AGENDA

President and Board of Trustees
Village of Arlington Heights
Board Room
Arlington Heights Village Hall
33 S. Arlington Heights Road
Arlington Heights, IL 60005
January 22, 2019
8:00 PM

Narrative - Changes to Plan

ENTRANCE IDENTITY SIGNAGE ON ARLINGTON HEIGHTS ROAD

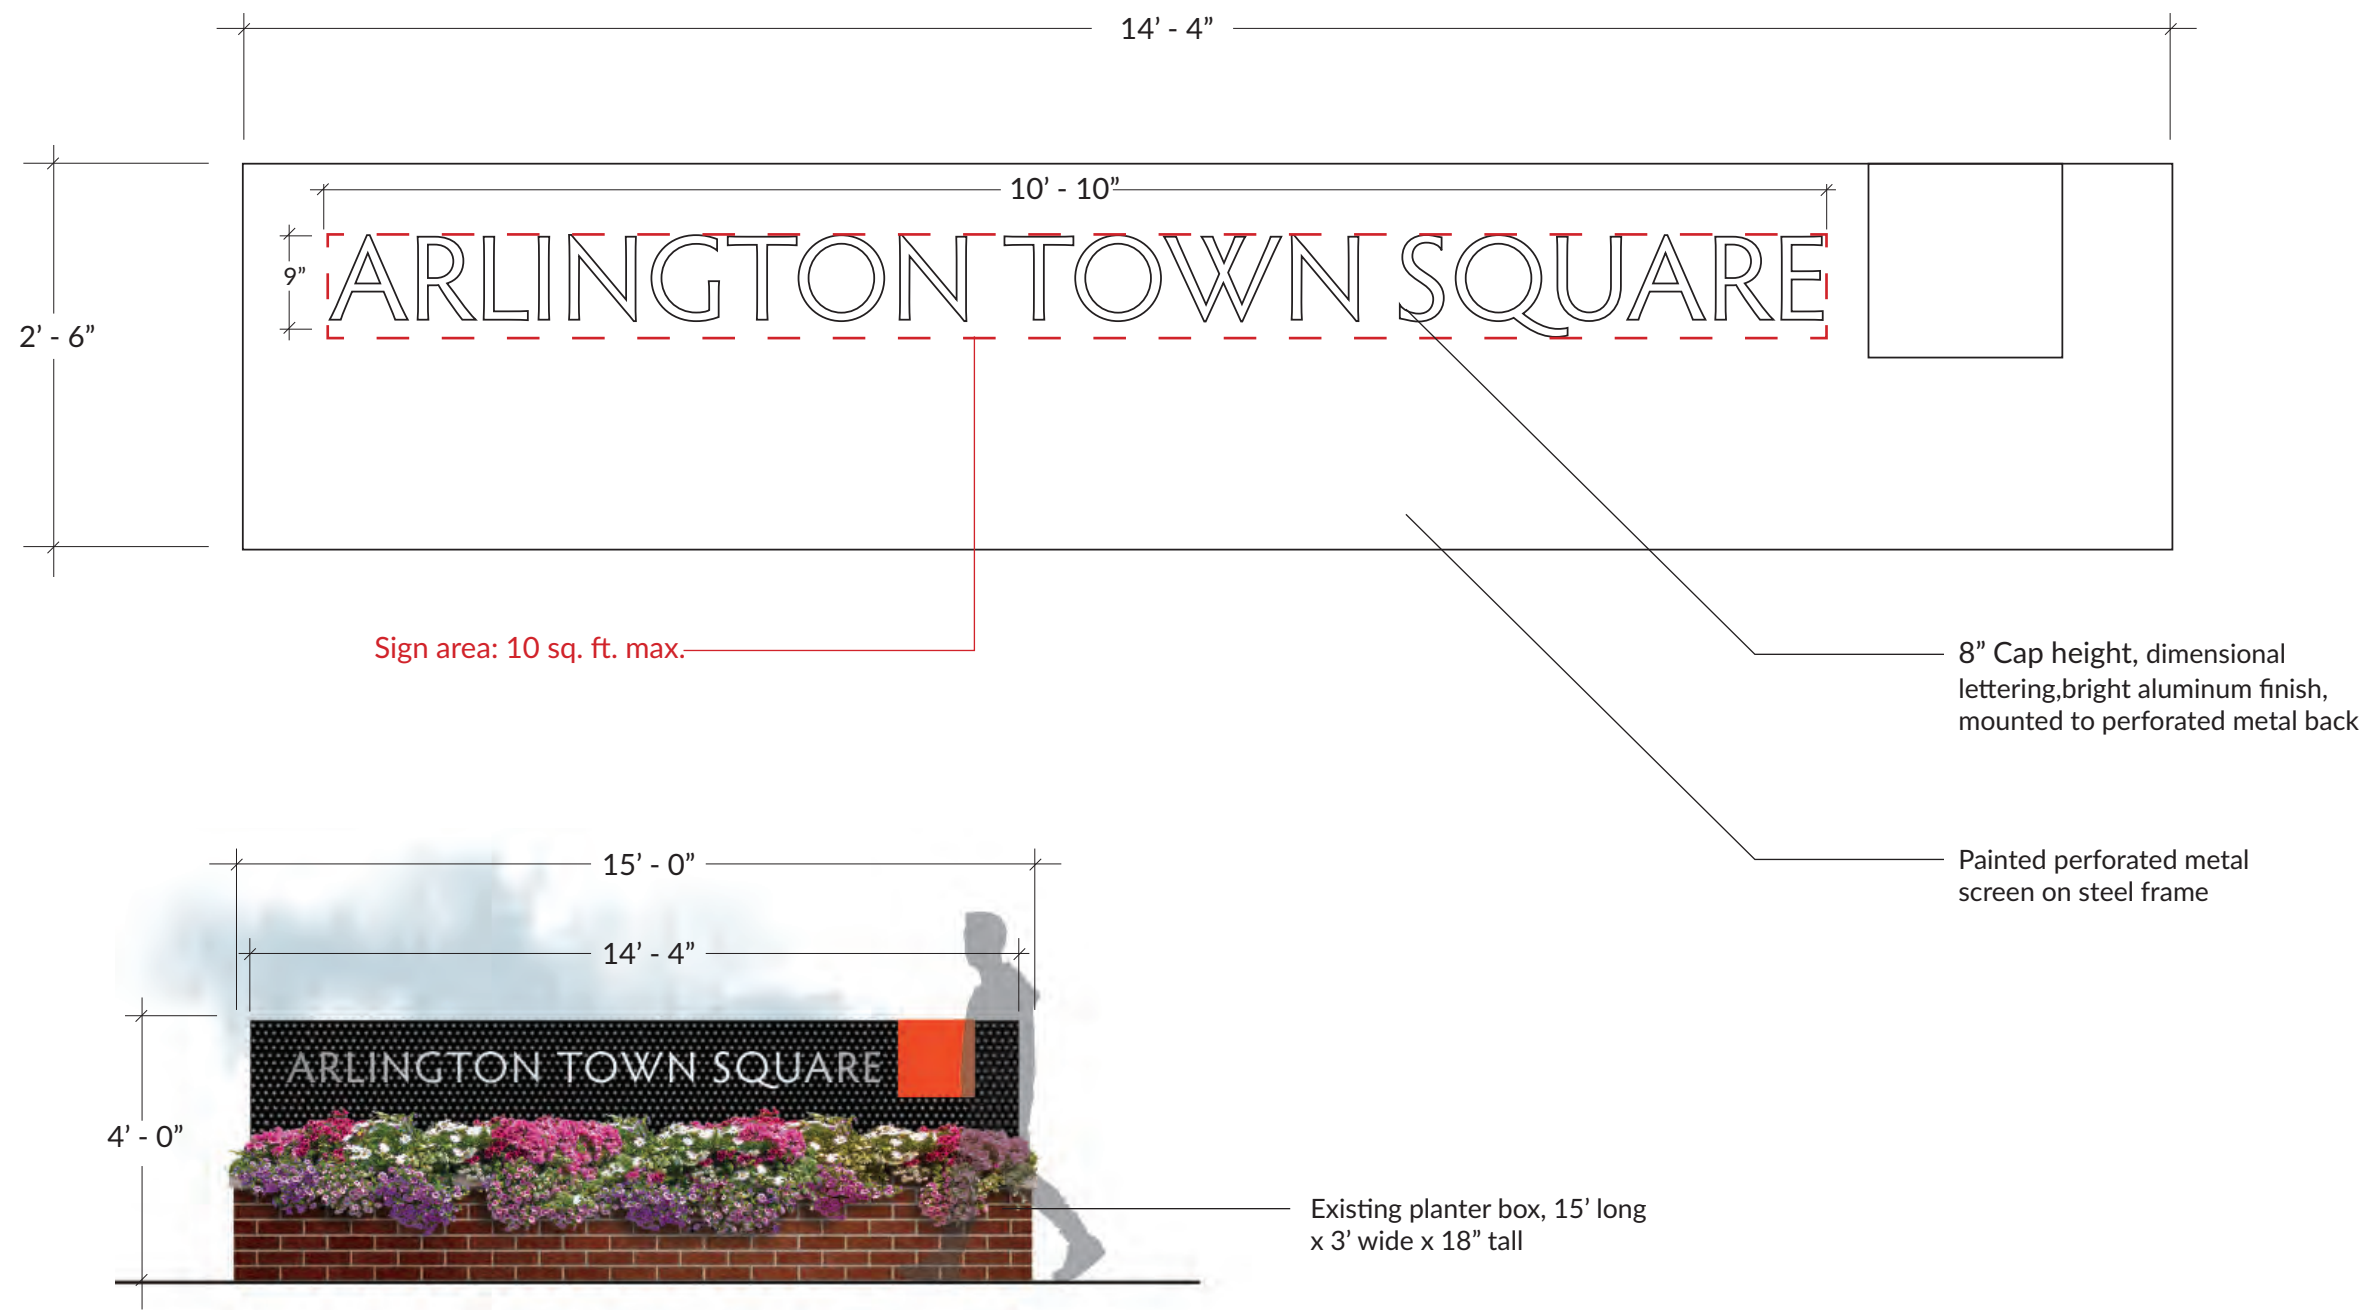
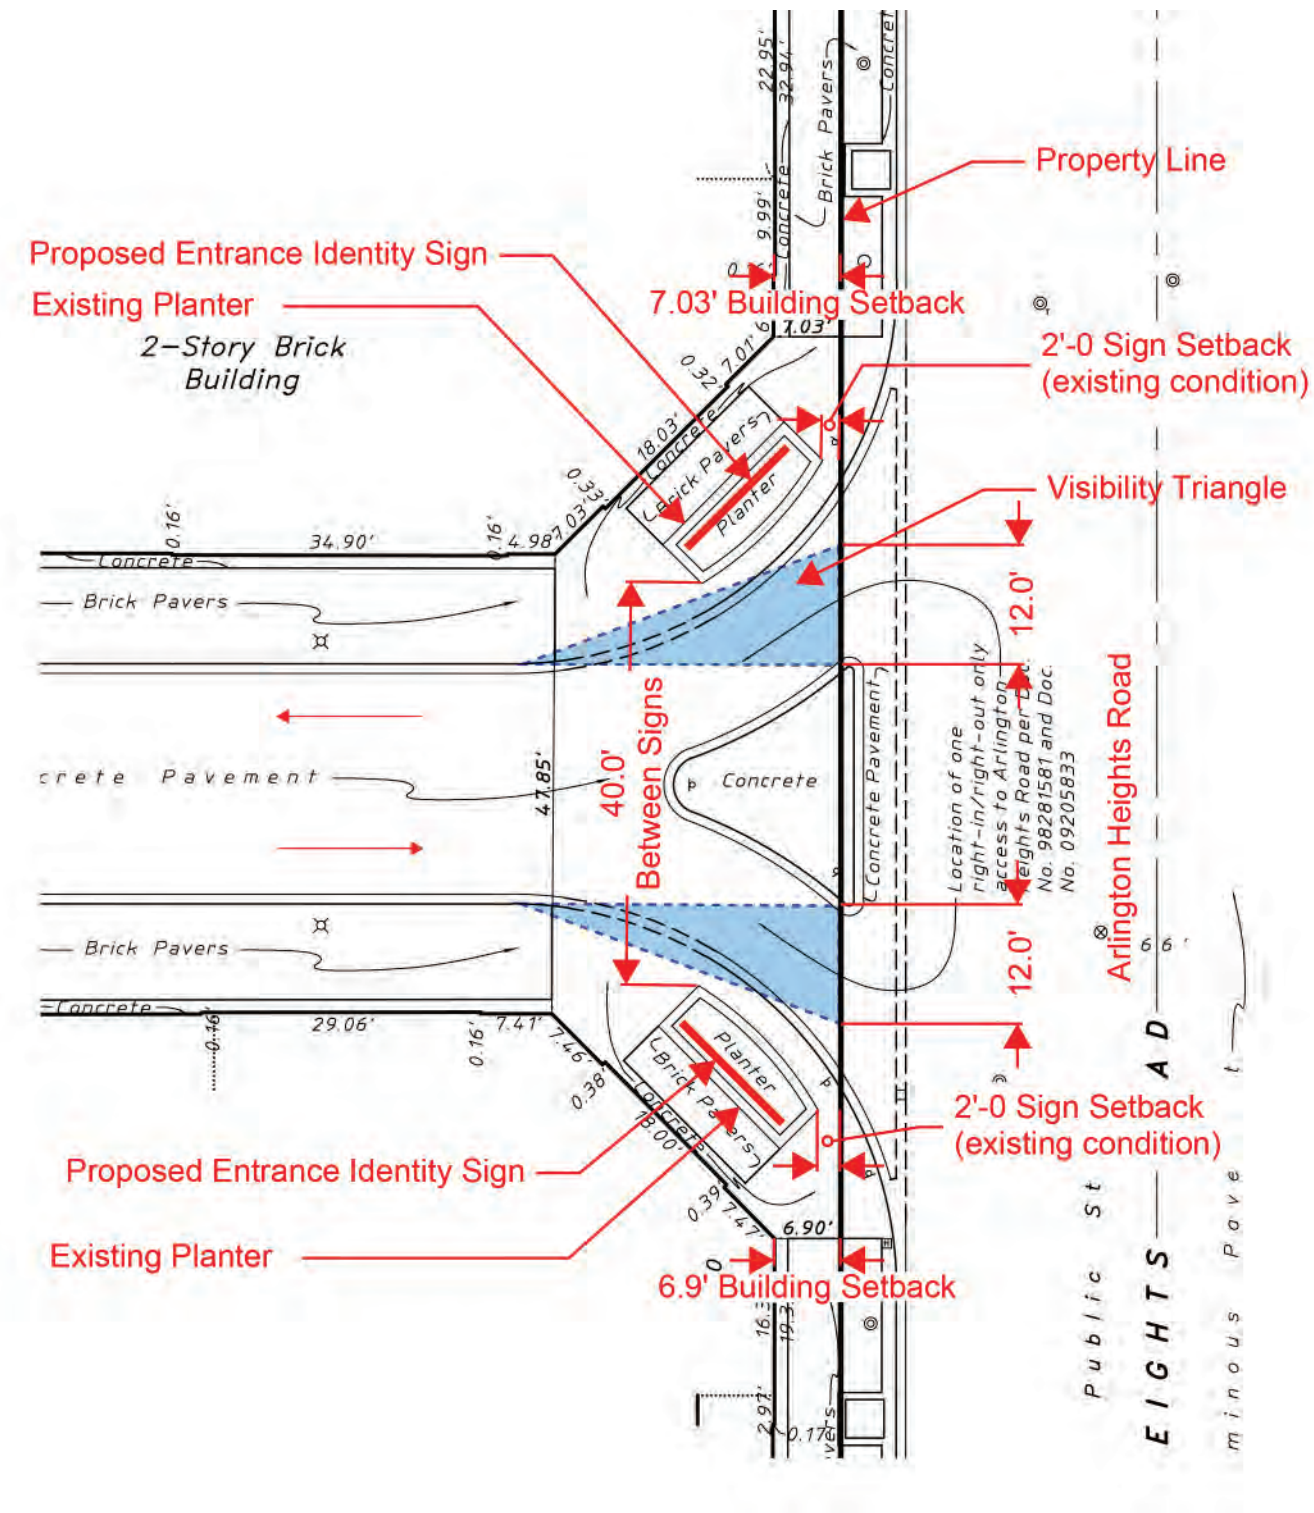
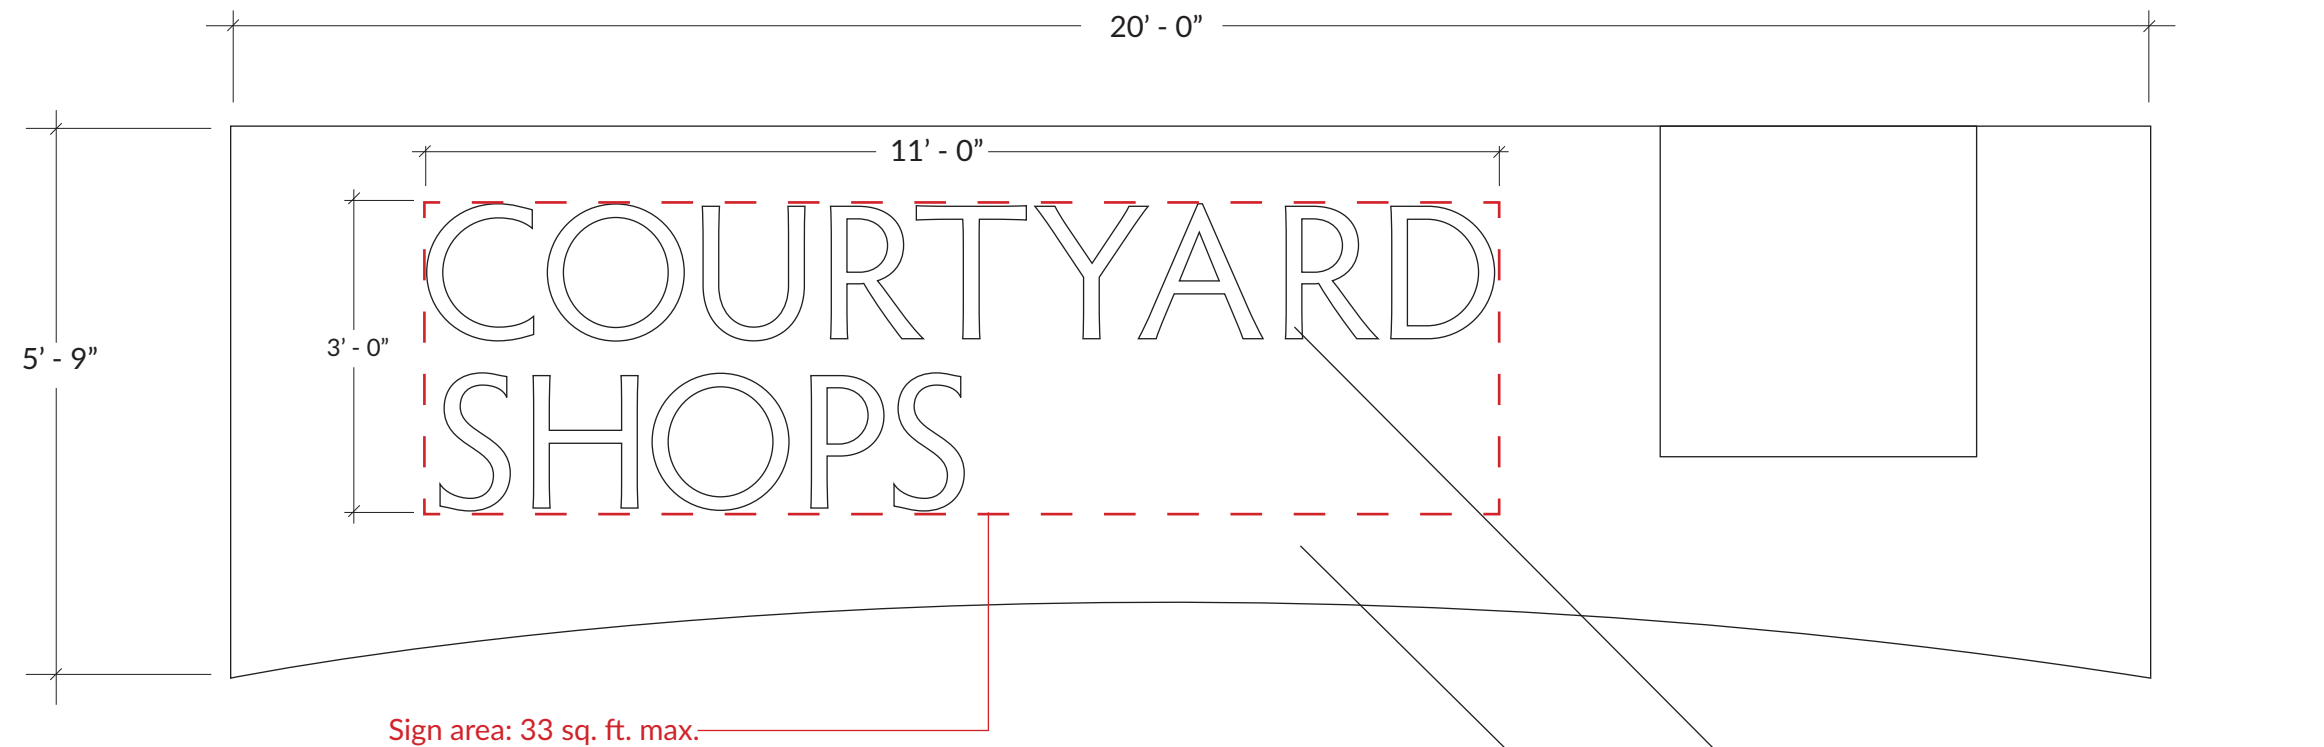
- The ground signs facing Arlington Heights Road will help to guide customers into the development, and the request for two signs is justified based on the existing layout of the entrance drive and planters. The signs are small and tastefully designed. Consider adding external illumination so the signs will be visible in the evening.

Commissioner Kingsley agreed with Staff's suggestion to add lighting to the two planter signs, and she liked that the current light fixtures on the columns were being replaced, although she cautioned the petitioner that the source of the new lighting should not be visible to either pedestrians or cars. She also agreed with Staff's recommendation that if the fountain signage is backlit, the portion of the panel behind the letters should be solid instead of perforated.

Commissioner Eckhardt had no issues with the new identification sign at Evergreen Avenue, or the two new blade signs, which he felt were appropriate. He would make it a requirement to light the two new ground signs in the existing raised planters on Arlington Heights Road, and he suggested using the LED strip underneath the light box on top of the framing, which would nicely wash the new sign and not be a distraction. He was okay with the proposed upgrade to the existing 'Courtyard Shops' entrance sign, which is substantially compliant with the previously approved variation, and he was in support of amending the previous variation to allow a new, larger Courtyard Shops Directory sign.

1. A REQUIREMENT THAT THE TWO GROUND SIGNS BEING ADDED TO THE EXISTING RAISED PLANTERS FACING ARLINGTON HEIGHTS ROAD BE ILLUMINATED WITH PREFERABLY LED LIGHT TO BE MOUNTED TO THE TOP OF THE FRAME OF THE SIGN THAT WILL NOT RESULT IN GLARE TO PEDESTRIANS OR CARS. STAFF SHOULD REVIEW THE LED COLOR TEMPERATURE OF THE LIGHT.

VARIATION 4

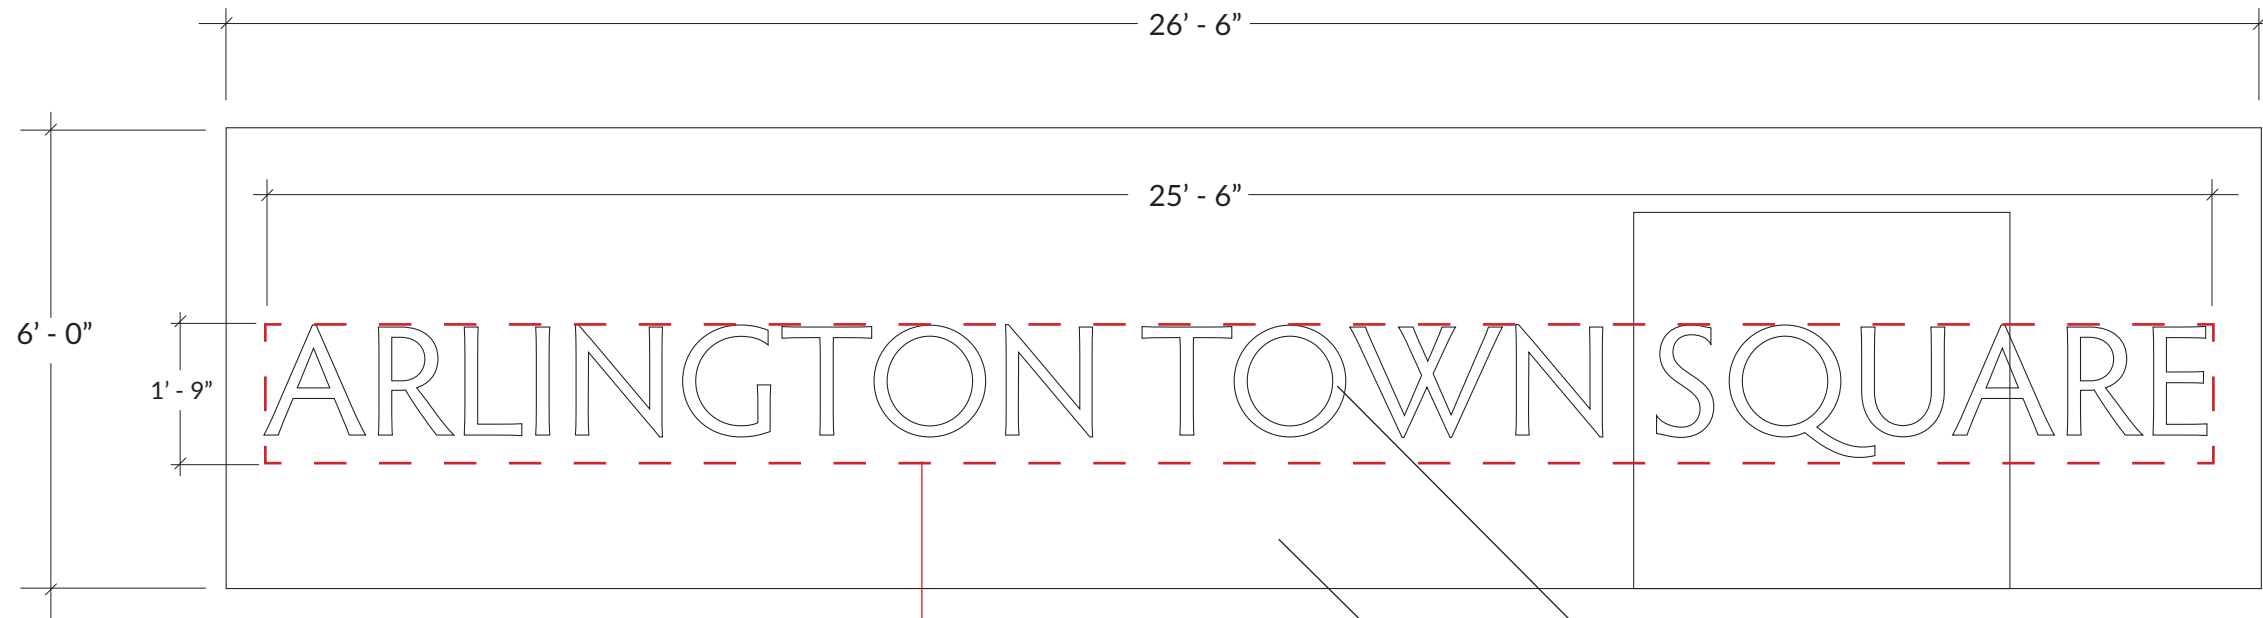
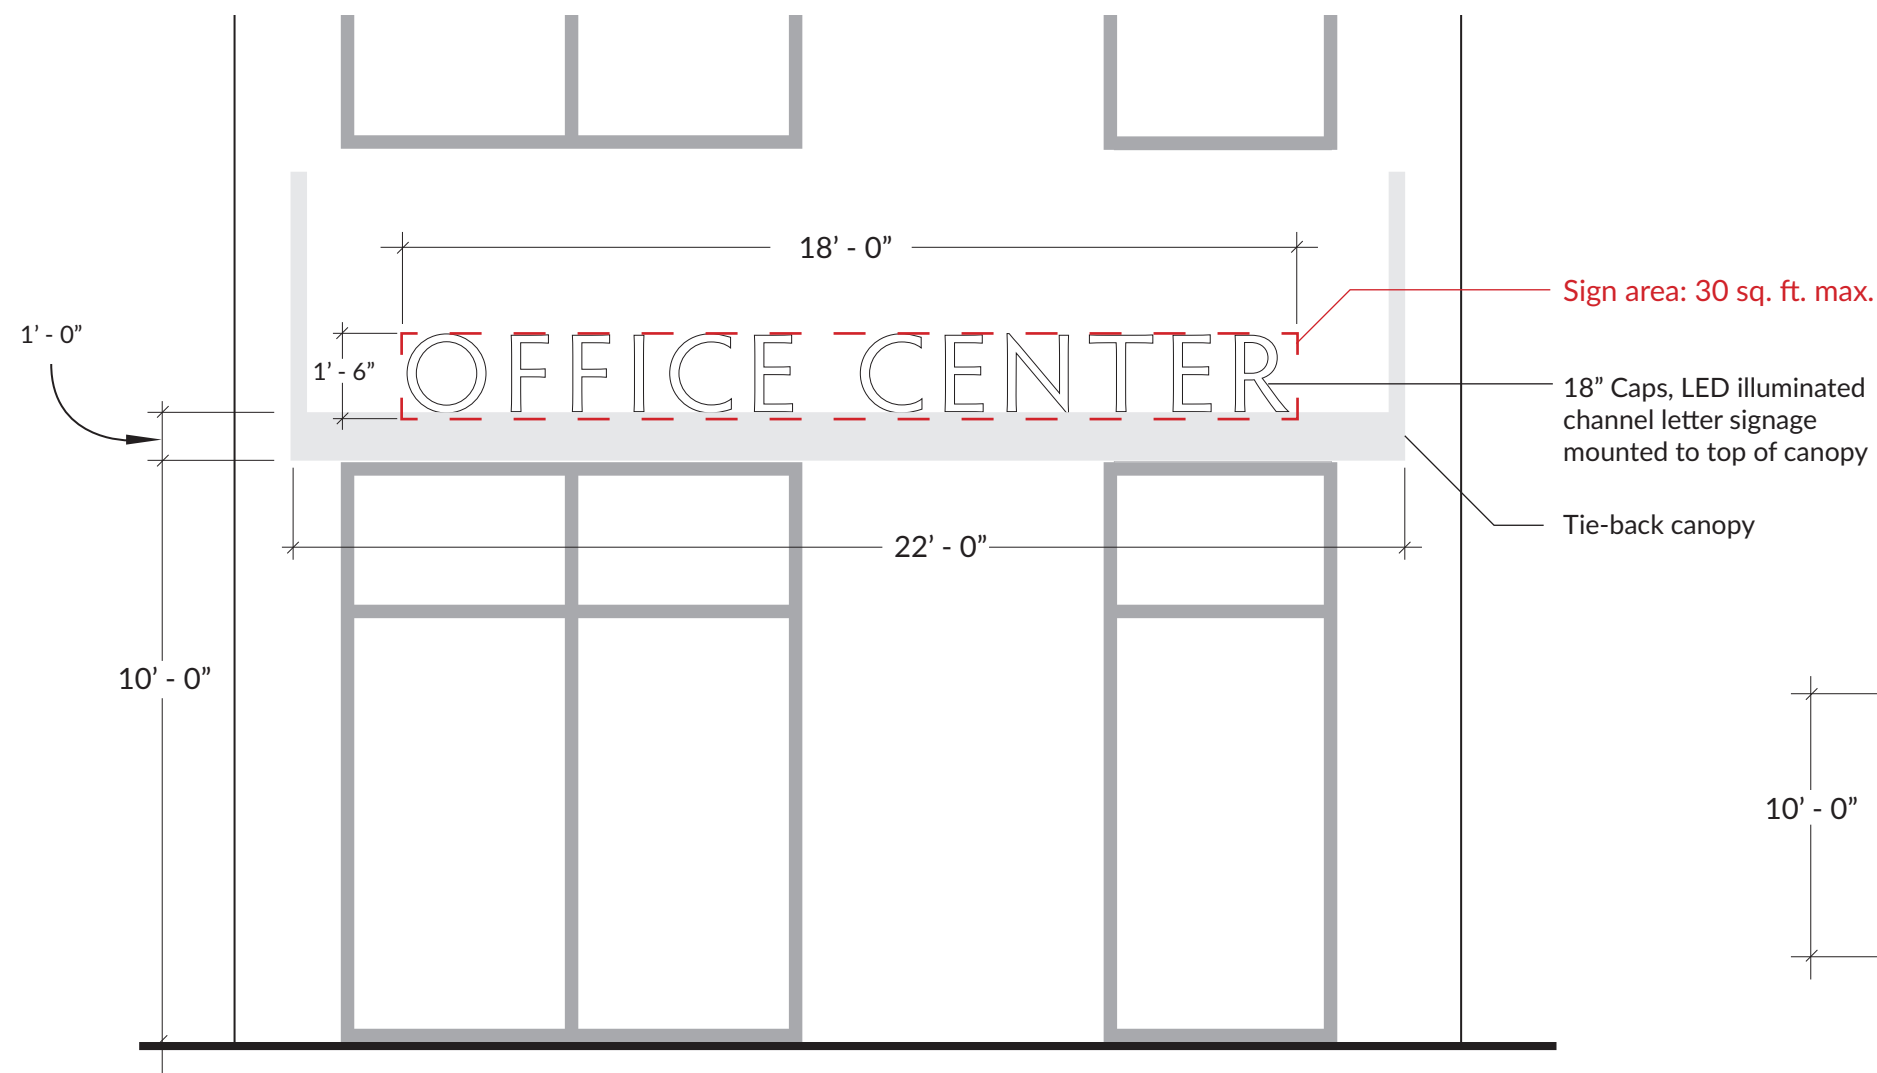
6. **Town Square Fountain.** A 45 sf “ARLINGTON TOWN SQUARE” development identification sign is proposed to be added to the existing fountain feature that is located along the internal drive aisle in the middle of the shopping center. A painted perforated metal screen is proposed to be added between the existing brick piers. A variation is required to allow the 45 sf development identification sign.
